PLANNING APPEAL FULL STATEMENT OF CASE

Formation of a new 2 storey detached 3 bedroom (class C3) residential dwelling; including formation of waste storage; cycle store; parking and Amenity space.

1 Adelphi Crescent UB4 8LY

January 2021

Figure 1
Open gap between 1 Adelphi Crescent and 3 Adelphi Crescent

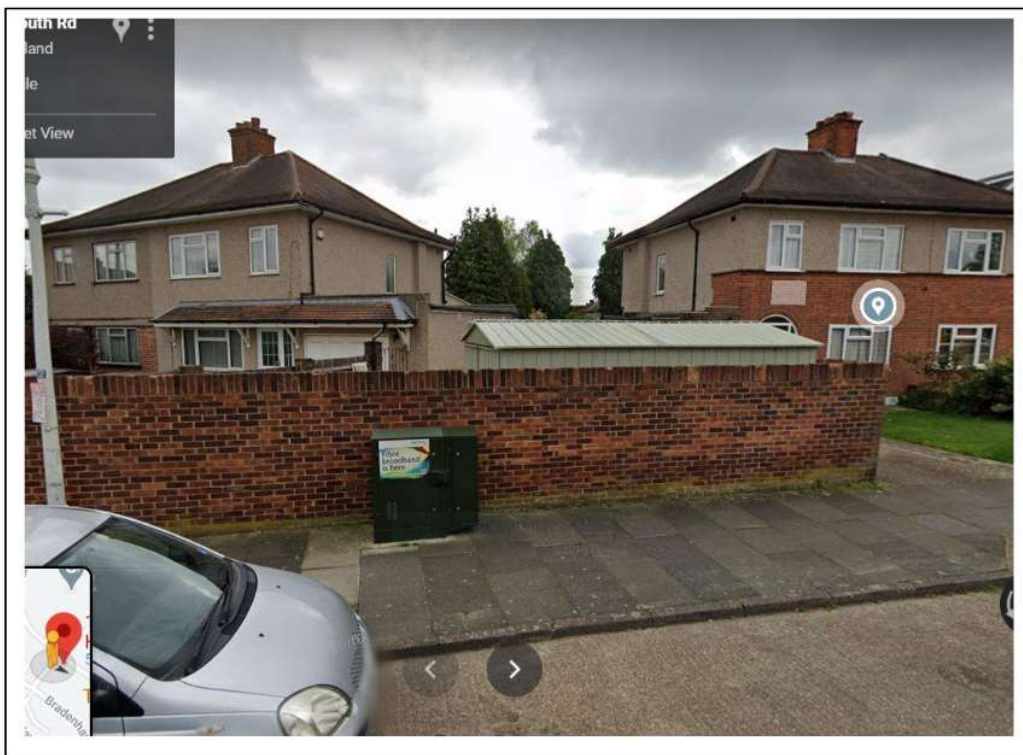
The application site, together with other corner properties in the vicinity are defined by large open spaces to the side of the existing dwellings. It is considered that this open space character gives several properties in the immediate locality, including the application dwelling, the appearance of significant spaciousness within their plots and makes a positive visual contribution to the appearance of the street scene.

We recognize the spaciousness to the side of the host dwelling and surrounding properties. We also observed the scale of the space to the side of the host dwelling compared to similar corner plots nearby, we believe that the existing open space beside the host building is unbalanced in size scale and depth compared to other corner plots. This can be seen on figure 1 to 5 above.

By introducing our proposal to the site, the site open space to side of the host building is better balanced as demonstrated on Table 2 above. The existing open space to the host building amounts to approximately 197m², this amount to 300% of similar neighboring corner sites in the immediate area.

After introducing our proposal, the open space to the host site has been reduced to 150% of the largest open space to neighboring corner sites. By introducing our proposal, we have harmonized the local context of the surrounding; we have reduced the open space to size that is in keeping with neighboring corner sites.

Figure 6

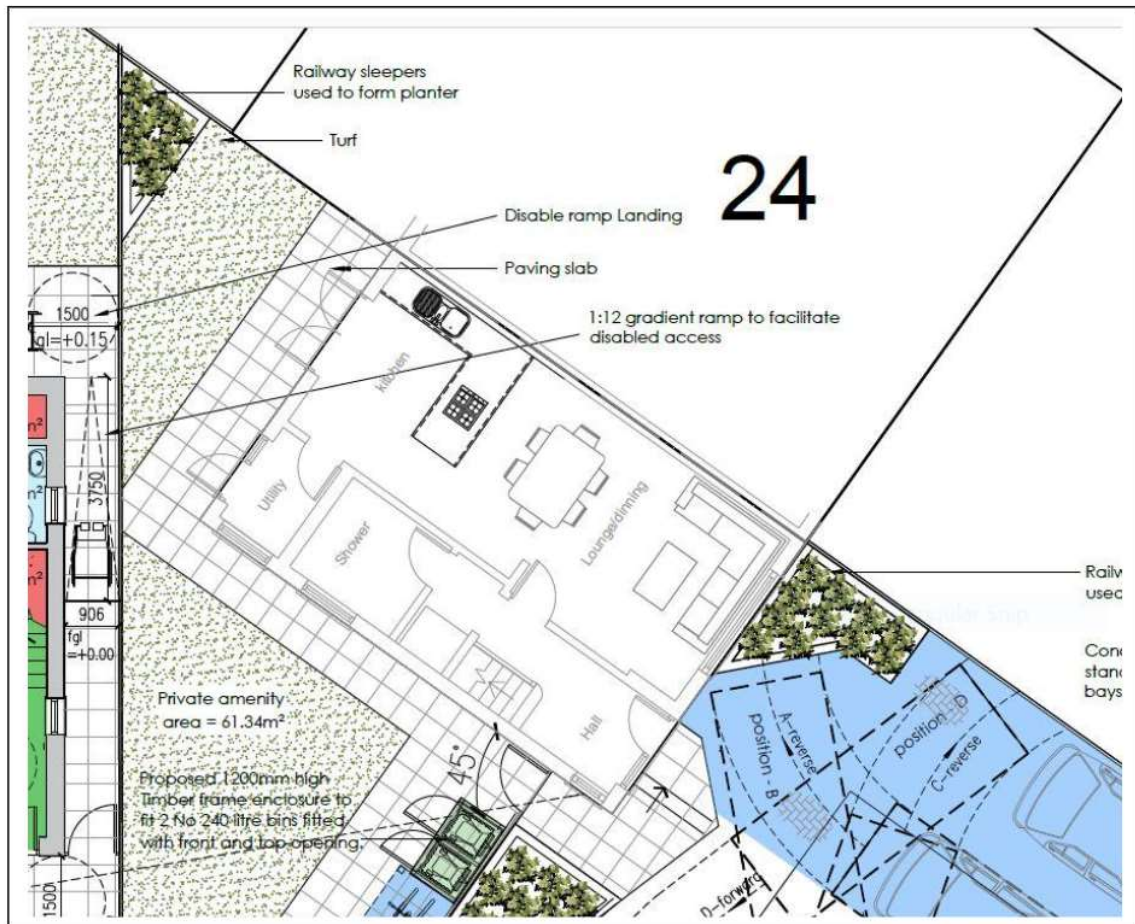
The proposed dwelling, by reason of its siting, size, scale, bulk and proximity, would be detrimental to the amenities of the adjoining occupier at 1 Adelphi Crescent by reason of overdominance, overshadowing, loss of light, visual intrusion and loss of outlook. Therefore the proposal would be contrary to Policy DMHB 11 of the Hillingdon Local Plan: Part Two - Development Management Policies (January 2020).

The window that looks onto the proposed dwelling are either that of non-habitable room or a room that have another primary light source other than the one being overshadowed by our proposal.

We propose to redesign the existing ground floor to the host building (1 Adelphi Crescent) into a through kitchen/dining/lounge, with this arrangement the front window to the lounge become the primary light source to the room and the rear serves as an exit into the garden and an additional source of light. The front window becomes the outlook source to the room; overshadowing and overdominance issues are resolved because the rear doors are not a primary source of light to the through lounge/dining/kitchen. See figure 6

Existing ground floor arrangement re-designed as a through lounge where the lounge, dining and kitchen are amalgamated into a single room and the primary light source is the frontal window.

Figure 7

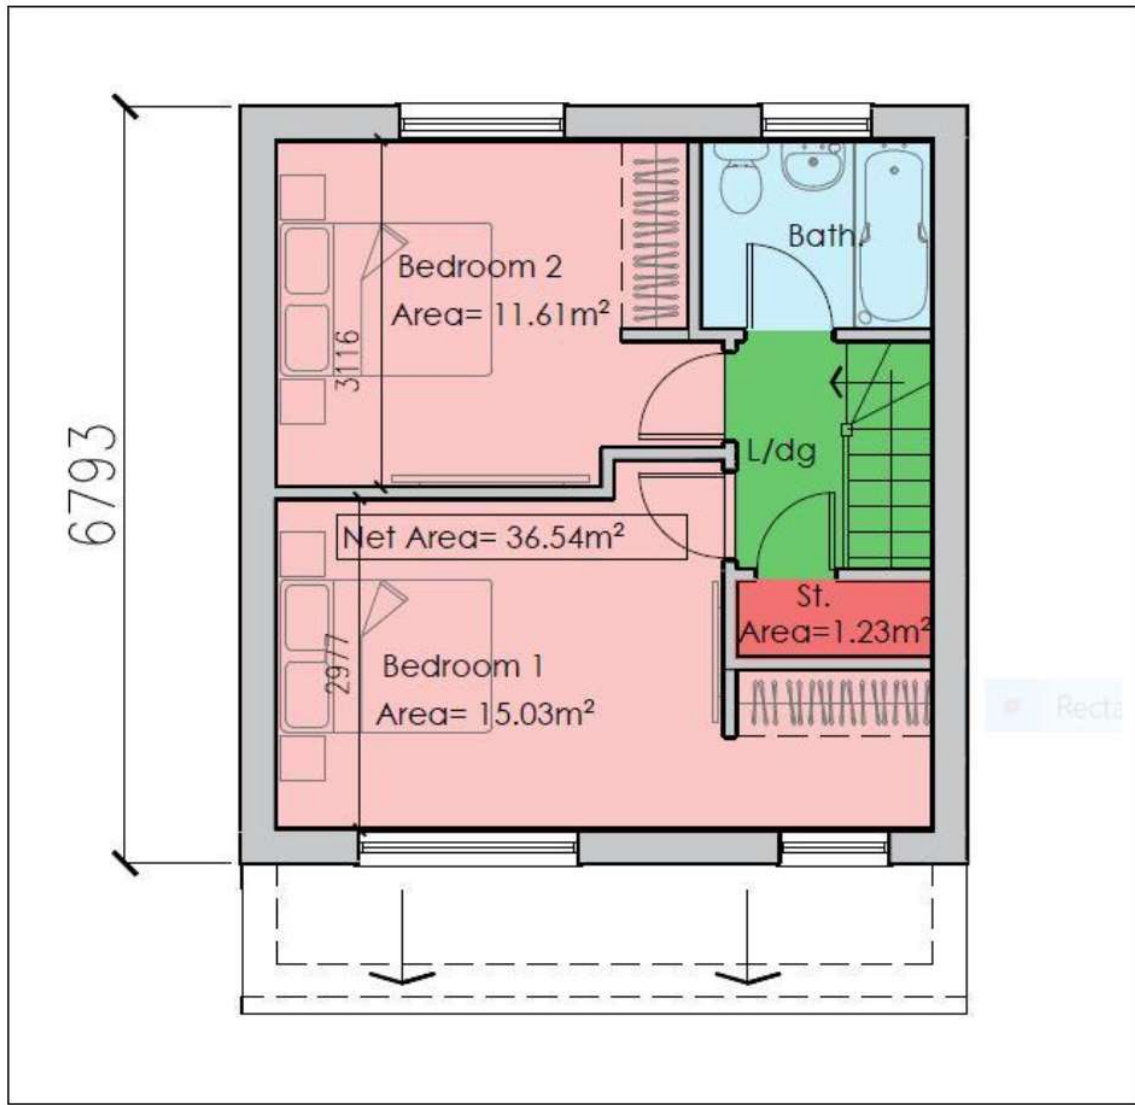
The proposal would provide a double bedrooms of an unsatisfactory size and quality for the future occupiers of the proposed dwelling and would therefore give rise to a substandard form of living accommodation to the detriment of the amenity of future occupiers. The proposal is thus contrary to Policy DMHB 16 of the Hillingdon Local Plan: Part Two - Development Management Policies (2020), Policy 3.5 and Table 3.3 of the London Plan (2016), the Housing Standards Minor Alterations to The London Plan (March 2016), the Mayor of London's adopted Supplementary Planning Guidance - Housing (March 2016) and the Technical Housing Standards – Nationally Described Space Standard (March 2015).

The second bedroom has been amended to meet the standard size.

We have previously proposed a double room of 16.09m² and a second bedroom of 10.59m².

We have revised this to 2No double rooms of 15.03m² & 11.61m².

Our amended plans meet the housing standard - Nationally Space Standard (March 2015). set out above. See figure 7

Figure 8
Wheel chair access to property

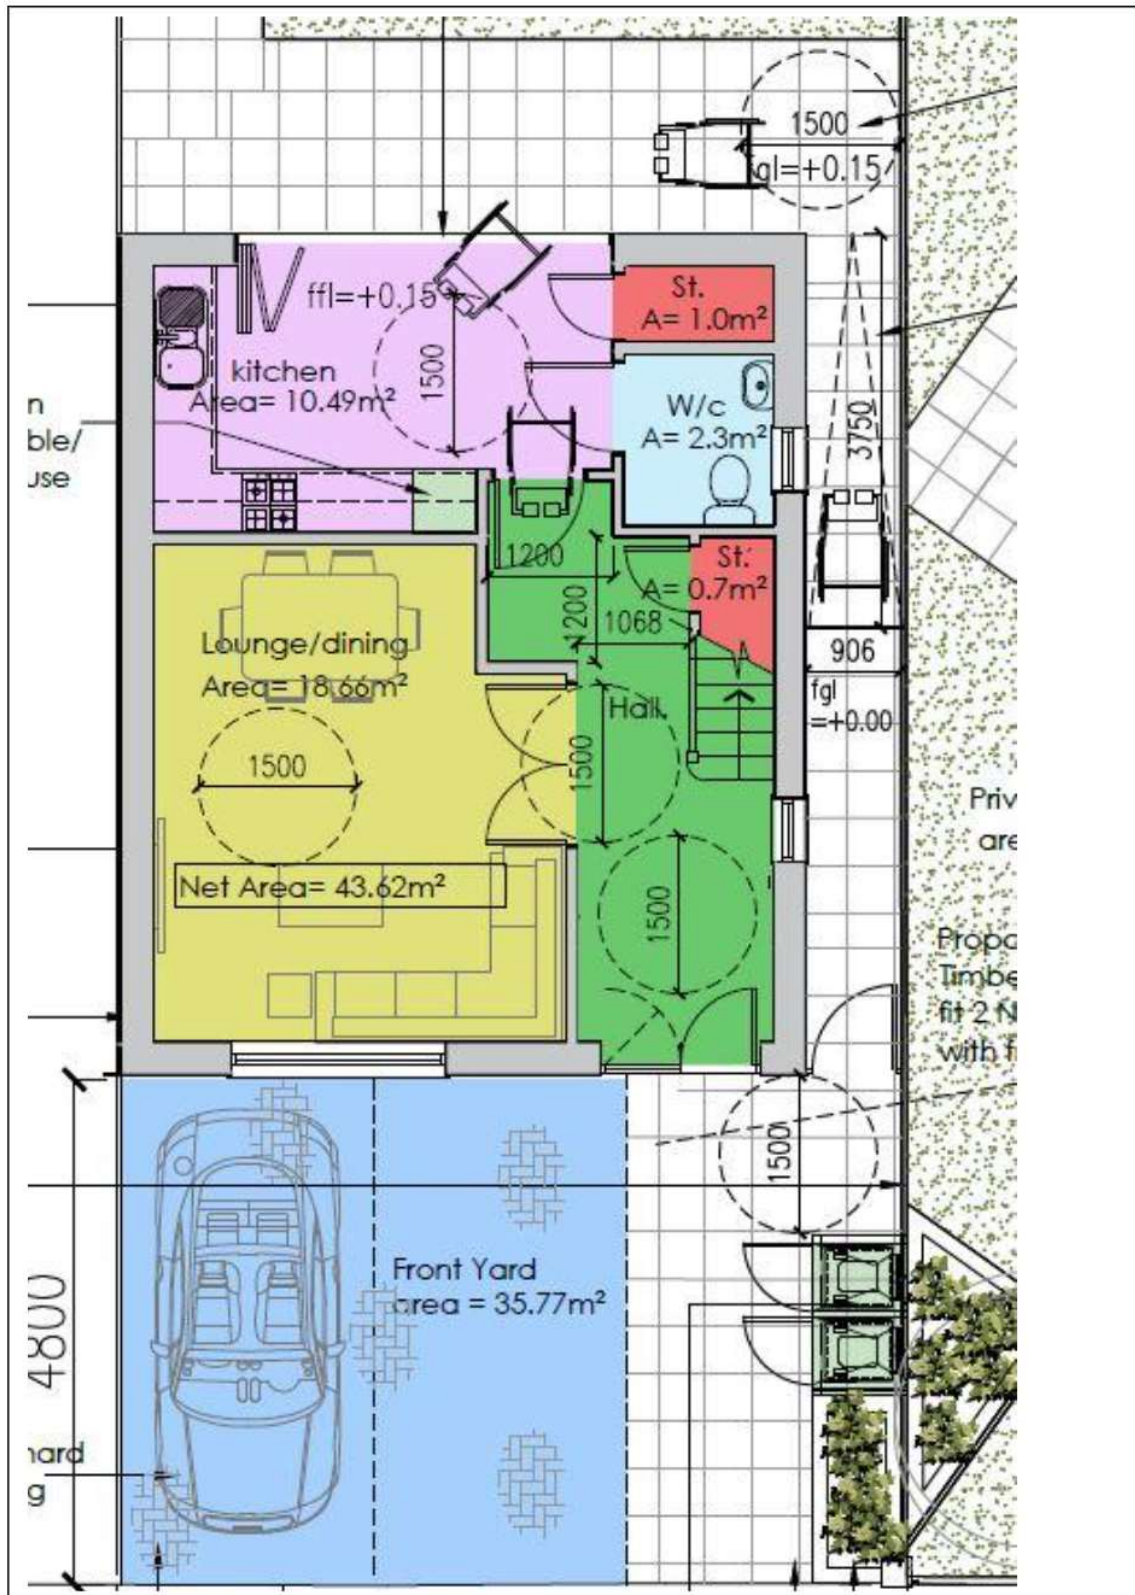
above Policy requirements as follows: 1. The porch as shown on plan achieves an inadequate distance of circa 750mm between the swing of the outer door and the inner

porch door. This should be increased to a distance of no less than 1500mm in accordance

with Diagram 23 as set out in Approved Document M to the Building Regulations 2010

(2015 edition). 2. The hallway width falls below the minimum standard required, particularly on the approach to and into the proposed kitchen. The hallway should be no

less than 1200mm wide on the approach into the kitchen.

Our proposal has been amended to be wheelchair accessible, the comment on the refusal has been addressed as follows:

The porch has been omitted and now forms part of the hall; hence we can achieve a 1500mm turning circle in the hall area.

The approach to the kitchen has been amended to 1200mm wide to make it compliant.

We have proposed a 1:12 gradient ramp to the side the building that lead onto a landing to the rear of the property. We proposed a flush threshold at the front and rear entry to the property. See figure 8

Figure 9

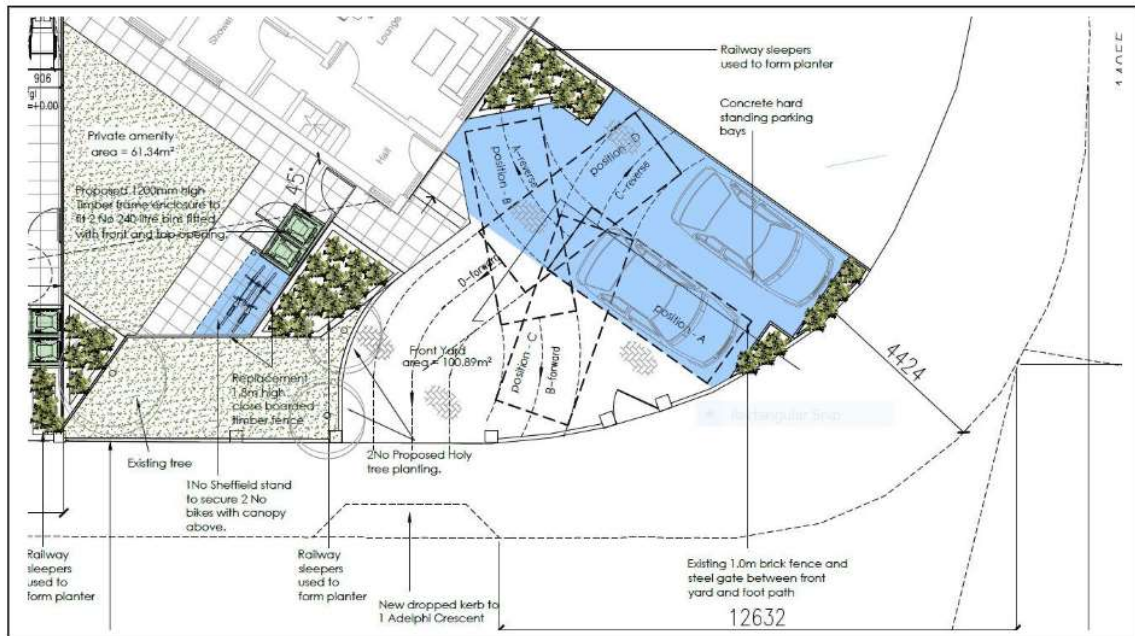
The proposal would necessitate the introduction of a long driveway to serve the 2 proposed parking spaces on the frontage of Number 1 Adelphi Crescent. The revised plans do include some soft landscaping, however, the frontage would still be dominated by hardstanding which would detract from the character and appearance of the area in conflict with Policy DMHB 11 and DMHB 14 of the Local Plan - Part Two (2020).

Vehicular Ingress and egress to redesigned to improve soft landscaping, long driveway omitted, proposed additional tree planting to soft landscape to improve front garden amenity.

The tree planting is also in response to the Landscape officers comment relating to replacement of the only existing tree on site as it might not survive the construction stage. See figure 9

The long driveway has now been omitted. This was achieved by relocating the vehicular ingress and egress to the host site. The proposed dropped kerb position remains more than 10 meters away from the junction.
